SHARP MANUFACTURING SYSTEMS CORPORATION

### Type of Notification: Model Name Change

ISSUE DATE	NOTIFICATION NO.	CHANGE TIMING	
2015/7/1	PCN- 20150701-01	2015/10/1

LCD Control Terminal, ZM500 Series

#### A. ZM500 Series Main Units

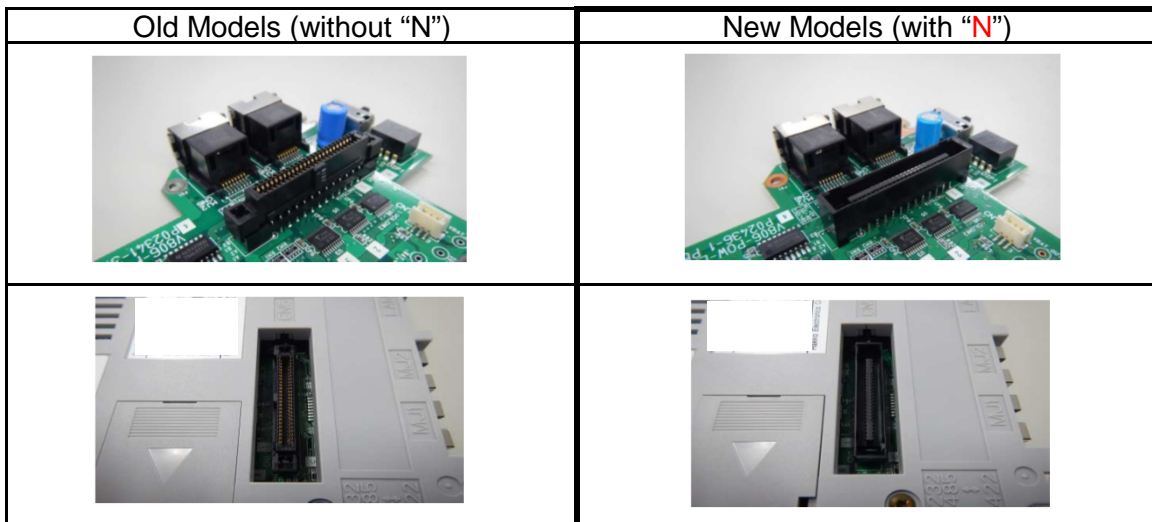
Due to unavailability of connectors, Sharp manufactures the above products with new connectors and changes the Model Names, accordingly.

The new connectors are not connectable with the old connectors. See the attachment for the details. Therefore, the old and new ZM500 Series models cannot be used in a mixed up manner.

1. Old models (having Model Name without "N") cannot be connected to new models (with "N") and vice versa because the connector shape is different.
2. The customers having ZM500 Main Units, ZM540DU and/or Communication Units, CU-xx, are requested to use them without mixing them up with the new models (with "N").

#### B. ZM-540DUx

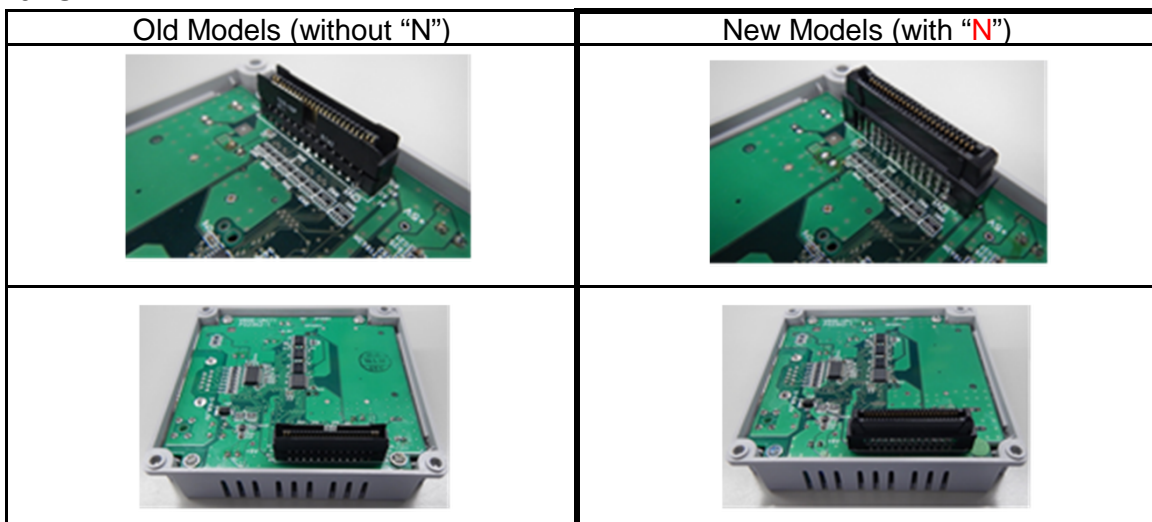
The connector is the same as that of ZM-540DUN.
